Access Compliance Report

Public Rights-of-Way

(Curb Ramps)

Intersection ID: 10025367	Main Street: E_8TH_ST	Cross Street: N/A	Location: E
ADA ID: ABE542F9B461	Ramp Type: Perp	Initial Pass/Fail: Fail	Overall Compliance: No
Severity Score: 13.75			
Codes/Mitigation Info/Possible Solution		Field Measurements/Component Compliance

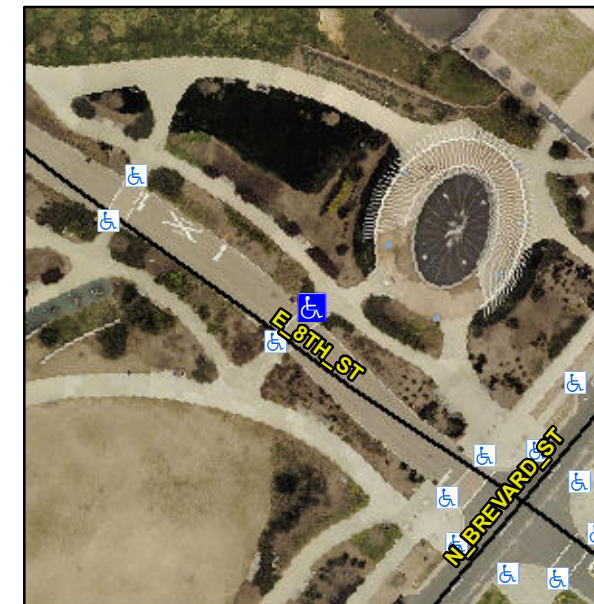
Remove & Replace Entire Ramp.

R304.2.2, R304.5.3

Compliance	Description	Data	Compliance	Description	Data
N/A	Ramp Length (in)	128.0	No	Ramp Slope (%)	9.0
Yes	Ramp Width (in)	60.0	No	Ramp XSlope (%)	4.1
N/A	Flare Type LT	N/A	N/A	Flare Type RT	N/A
N/A	Flare Slope LT (%)	N/A	N/A	Flare Slope RT (%)	N/A
N/A	Flare Traversable LT?	N/A	N/A	Flare Traversable RT?	N/A
N/A	Landing Length (in)	N/A	N/A	DWS Provided?	N/A
N/A	Landing Width (in)	N/A	N/A	DWS Contrast?	N/A
N/A	Landing Slope (%)	N/A	N/A	DWS Length (in)	N/A
N/A	Landing X Slope (%)	N/A	N/A	DWS Full Width?	N/A
N/A	Landing Curb? (Y/N)	N/A	N/A	DWS Offset (in)	N/A
N/A	Shared Landing?	N/A			
N/A	Gutter Ponding?	N/A	N/A	Gutter Slope (%)	N/A
N/A	Gutter Lip Ht (in)	N/A	N/A	Gutter X Slope (%)	N/A
N/A	Painted X Walk1?	Yes	N/A	Painted X Walk2?	N/A
	X Walk 1 Direction	To SW		X Walk 2 Direction	N/A
N/A	X Walk 1 Width (in)	120.0	N/A	X Walk 2 Width (in)	N/A
	X Walk 1 Slope (%)	1.0		X Walk 2 Slope (%)	N/A
	X Walk 1 X Slope (%)	2.1		X Walk 2 X Slope (%)	N/A
